RESOLUTION NO. R-2414

A RESOLUTION OF THE CITY COUNCIL OF THE CITY OF KIRKLAND APPROVING THE ISSUANCE OF A SUBSTANTIAL DEVELOPMENT PERMIT AS APPLIED FOR IN DEPARTMENT OF COMMUNITY DEVELOPMENT FILE NO. CUP-SDP-76-70(H) BY SHANNON DEVELOPMENT CO. TO LOCATE A COVERED PARKING FACILITY FOR 14 AUTOMOBILES AT 6201 LAKE WASHINGTON BOULEVARD N.E. AND COMMONLY REFERRED TO AS PEBBLE BEACH APTS. BEING WITHIN A WDI ZONE, AND SETTING FORTH CONDITIONS TO WHICH SUCH CONDITIONAL USE PERMIT AND SUBSTANTIAL DEVELOPMENT PERMIT SHALL BE SUBJECT.

SUBJECT Conditional Use Permit & Substantial Development Permit for Covered Parking for the Pebble Beach Apartments

**ADVISORY REPORT
DEPARTMENT OF COMMUNITY DEVELOPMENT
FINDINGS, CONCLUSIONS AND RECOMMENDATIONS**

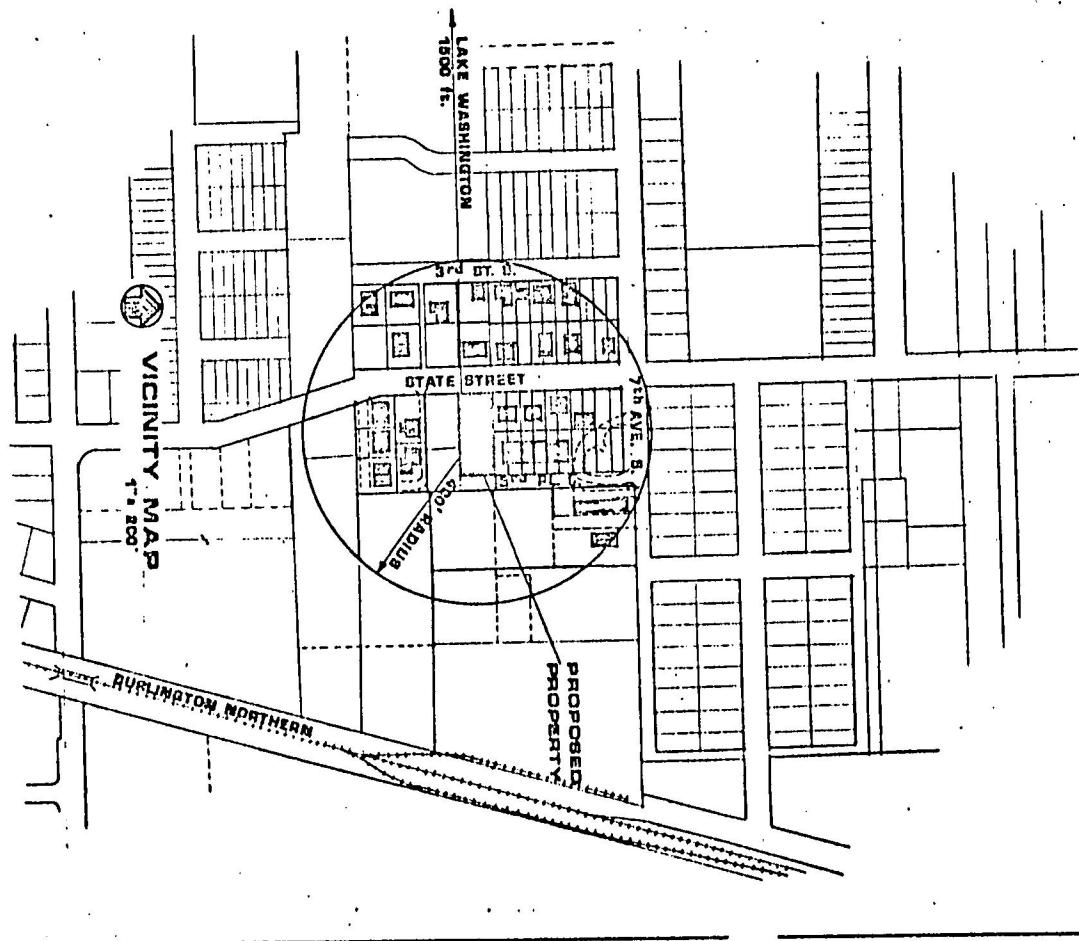
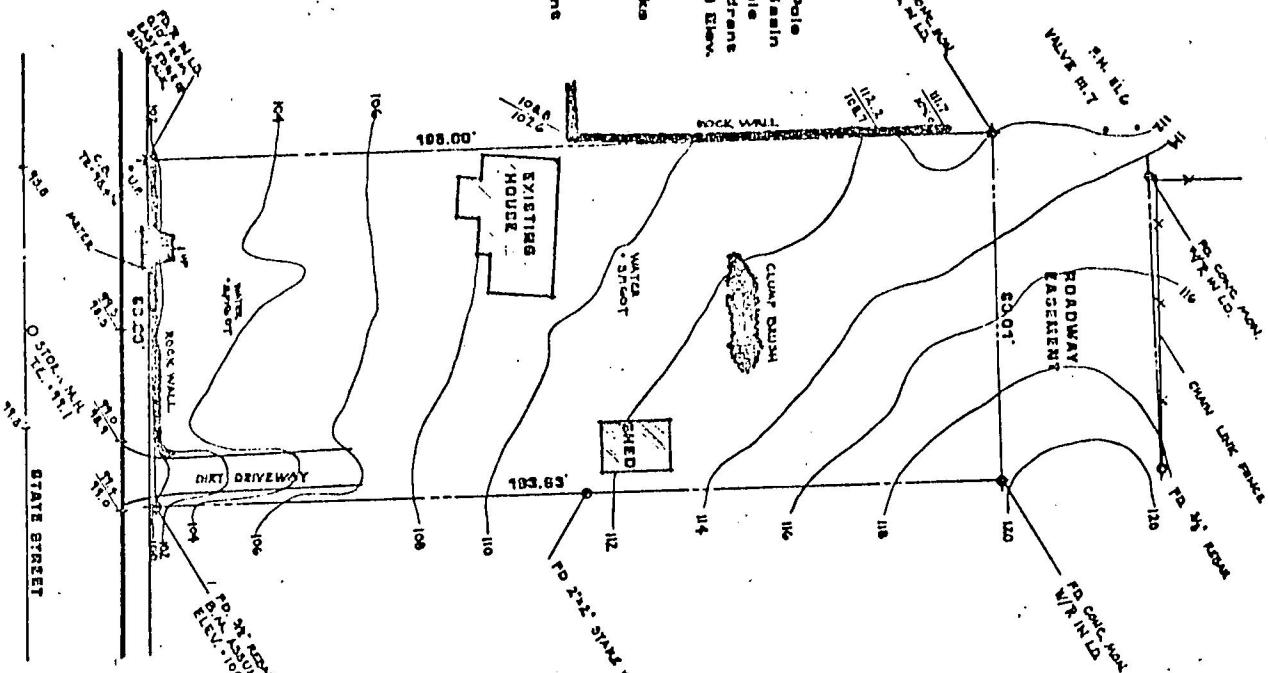
- a. Residential Multi-Family zone requirements: The proposed development plan as identified in Exhibit "B" conforms to the existing Professional Residential zone requirements regarding setbacks, height, and lot coverage.

- b: The proposed parking plan for the subject property generally conforms to the Kirkland Zoning Ordinance regarding parking standards with the addition of Conclusion 6.c.(1) as indicated above, and with the addition of such a 4-foot high Laurel hedge on a low berm (2-3 feet) located in the 6-foot landscaping area adjacent to Lakeview School's fence. (Refer to Exhibit "B".)

- Parking stalls 3 and 4 will be permitted in this plan as they are above street grade and not readily visible from State Street. The applicant should be required to slope these stalls toward the east to reduce the hazard of unattended vehicles rolling out onto State Street.

- c. Landscaping requirements. Exhibit "C" as submitted by the applicant is generally consistent with the spirit and intent of both the emerging Land Use Policies Plan and the Kirkland Zoning Ordinance. However, the recommended modifications to the proposed landscaping plan are listed as follows:

- (1) Refer to Conclusions 6.c.(1) and 7.b. as listed above.
- (2) Deciduous trees should be added along the west 95 feet of the north property line and placed 20 feet on center as along the southern property line. This is an area which is covered by Kirkland Zoning Ordinance Section 23.40.050.

1. Prior to applying for a building permit on the subject property the applicant shall make the following modifications to Exhibits B and C:
 - a. Insure adequate ingress and egress visibility from the State Street access point through reduction of landscaping and/or grading of the site within an area 20 feet back from State Street along said driving lane.
 - b. Contact the serving solid waste utility and locate an approved site-screened solid waste container.
 - c. Deciduous trees minimum 2" in caliper should be added along the west 95 feet of the north property line and placed 20 feet on center.

- g. Provide a minimum 5 foot wide asphalt path directly from 3rd Place South to the gate in the fence of Lakeview Elementary School. This pedestrian way should be physically separated from the vehicle lanes used in this application.

- h. All deciduous trees shall be a minimum of 2" in caliper, whereas, all evergreen trees shall be a minimum of 8-10 feet in height.
- i. Parking Stalls 3 and 4 shall be graded in an easterly direction to reduce the hazard of unattended vehicles rolling out onto State Street.

- j. The easterly duplex shall be site screened by either an architectural fence or landscaping from parking stalls 3 and 4 as per requirement of Section 23.40.060.
